TITLE: AIR CONDITIONING - INSTALL A MORE COMPACT LE BOZEC FILTER

This page transmits Revision No.02 of Service Bulletin No.A320-21-1139

Revision No. 02 issued to extend the effectivity (Service Bulletin No. A320-21-1152) and to modify the weight and balance.

Figure A-FBAAA - Sheet 01 Removal of the Fairing and the Plug

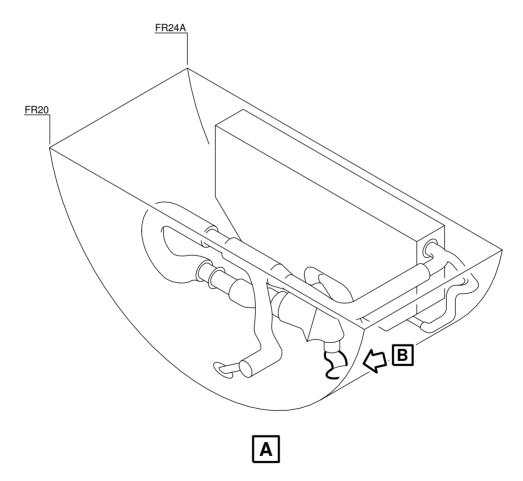
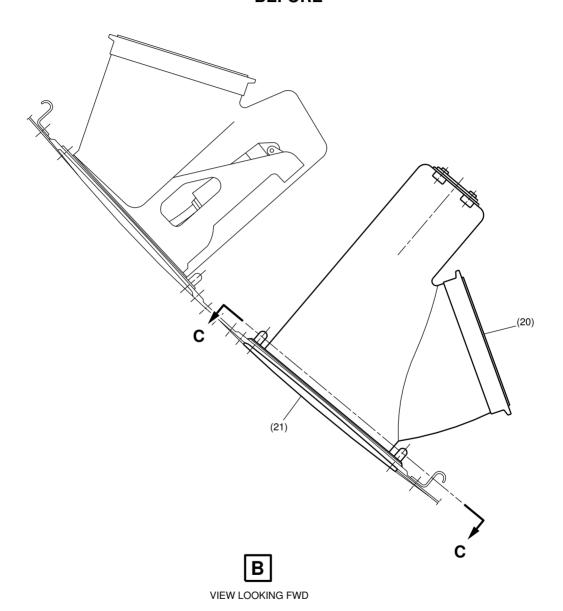
(1) Subtask 211139-831-001-001 - Remove the Fairing and the plug

(a) Remove the plug:

(b) Remove the fairing:

Figure A-FBBAA - Sheet 01 Installation of the Plug

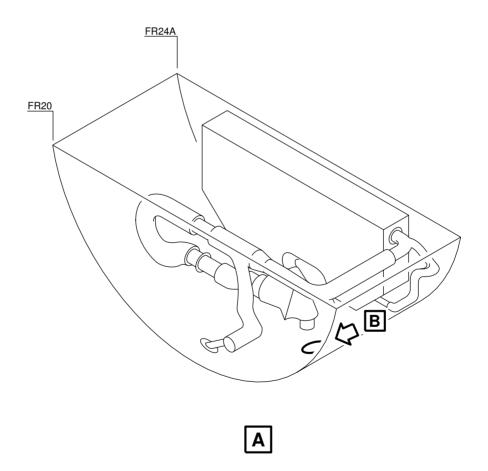
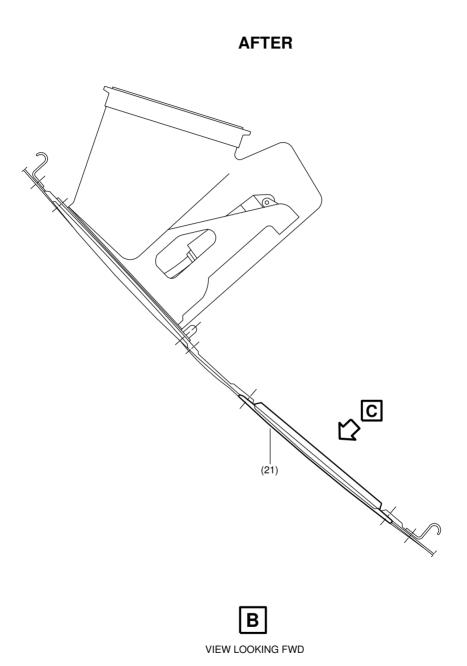
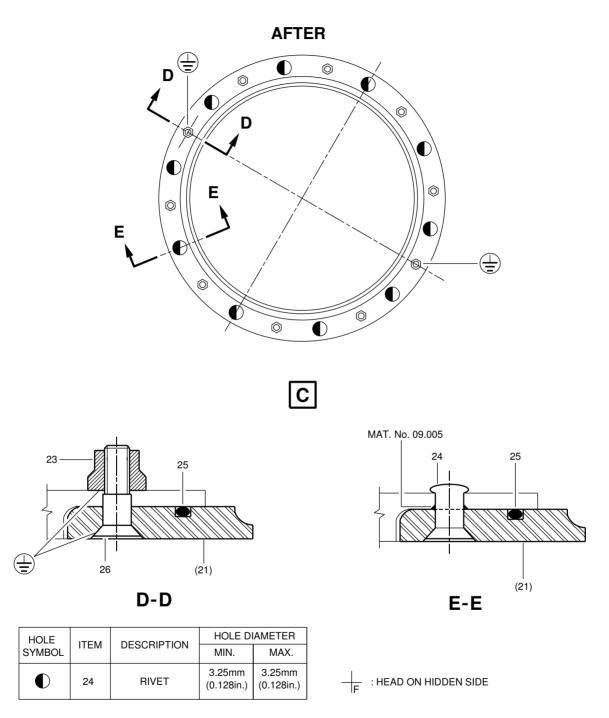
References		
Fig. A-FBBAA	Sheet 01 - Installation of the Plug	
	Sheet 02 - Installation of the Plug	
	Sheet 03 - Installation of the Plug

- (b) Drill ten holes on the plug Item (21) to match the existing holes of the structure.
- (c) Remove and deburr.
- (d) Install:

NOTE: APPLY MAT. No. 09.005 TO THE INTERFACE OF THE PLUG AND THE STRUCTURE

Figure A-FCAAA - Sheet 01 Removal of the LE BOZEC Filter

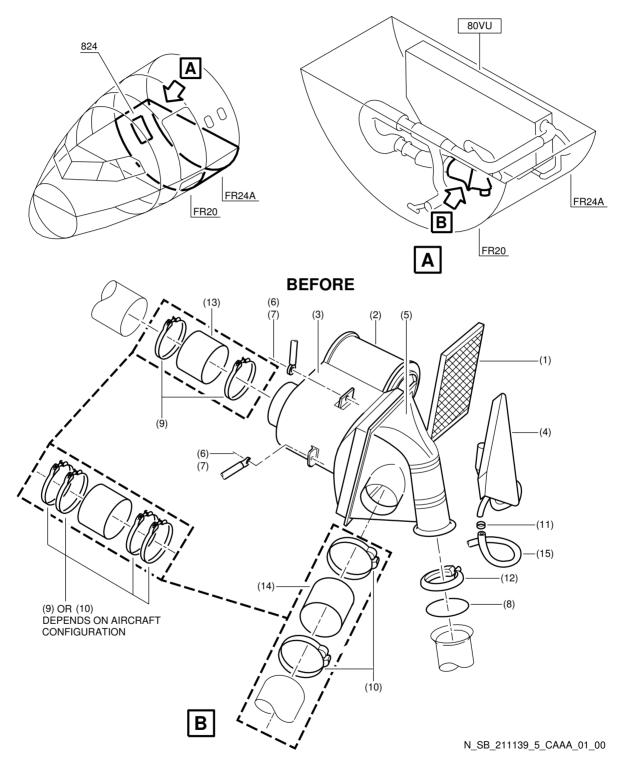
(1) Subtask 211139-020-001-001 - Remove the LE BOZEC Filter

Refer to Fig. A-FCAAA Sheet 01

Figure A-FCBAA - Sheet 01 Removal of the PALL Filter

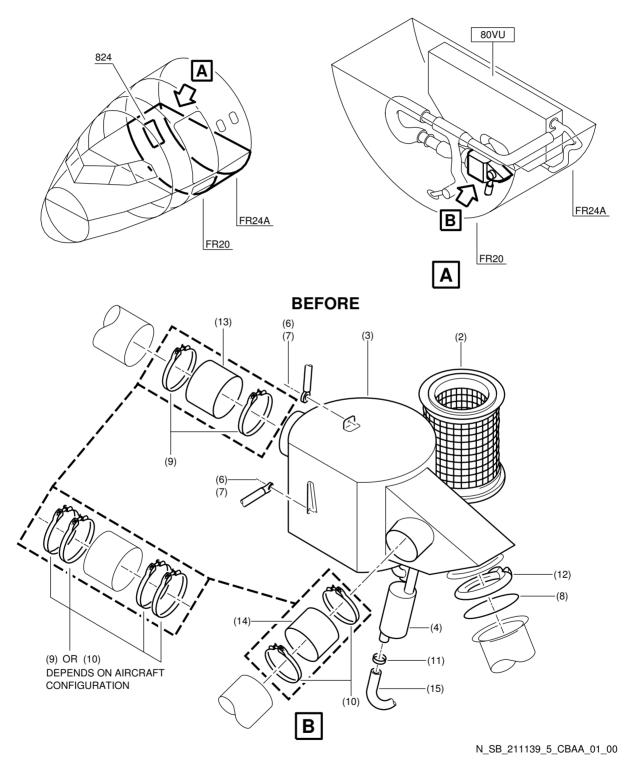
(1) Subtask 211139-020-001-002 - Remove the PALL Filter

Refer to	Fig. A	\-FCBAA	Sheet 01
----------	--------	----------------	----------

Figure A-FCCAA - Sheet 01
Installation of the New LE BOZEC Filter

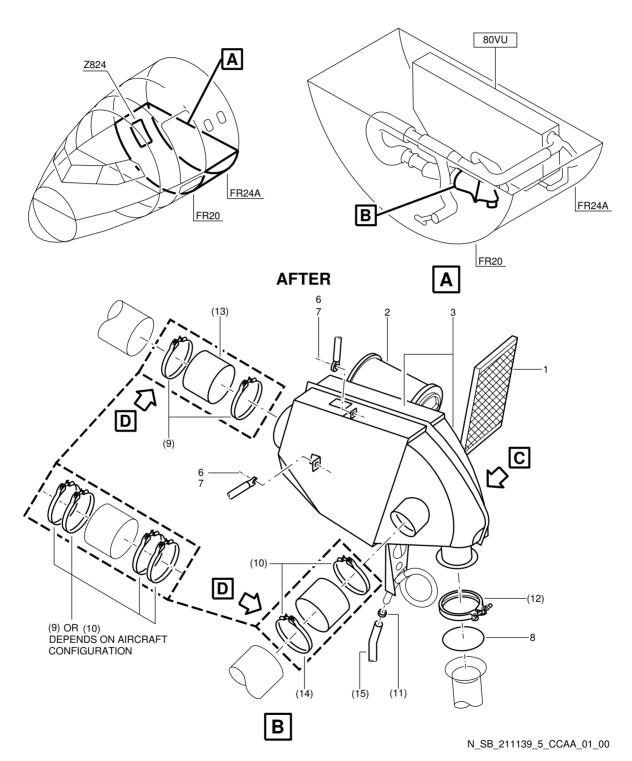
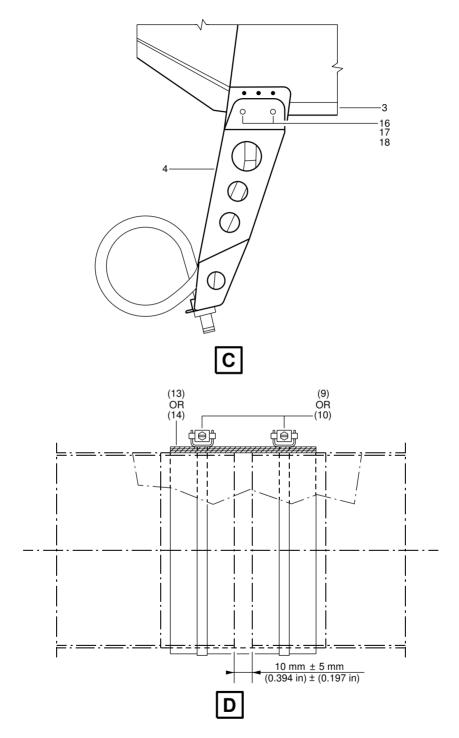
The new filter body is more compact with respect to the previous LE BOZEC FILTRATION and SYSTEMS filter, with a weight reduction of 3.0 Kg (6.614lb).

The pressure drop on the new equipment is 0.5 mB lower than the previous LE BOZEC FILTRATION and SYSTEMS filter.

The new filter has pressure ports to check the clogging level.

References			
Fig. A-FCCAA	Sheet 01 - Installation of the New LE BOZEC Filter Sheet 02 - Installation of the New LE		
	BOZEC Filter

Refer to Fig. A-FCCAA Sheet 01 and Fig. A-FCCAA Sheet 02
